TITLE: Pelican 1620 Transport Case Design Refinements

PRODUCTS AFFECTED: Pelican's 1620 Transport Case

INTRODUCTION: The 1620 Transport Case design has been modified (**Excluding models manufactured in Germany**).

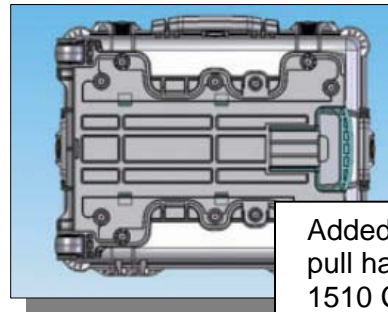
Added overmolded front and side handles

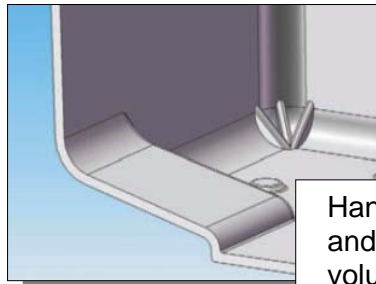
Added one-handed-action pull handle dolly (Similar to 1510 Carry On and 1560)

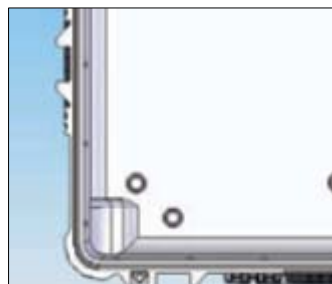
Inside wall thickness removed behind purge valve area to increase internal volume
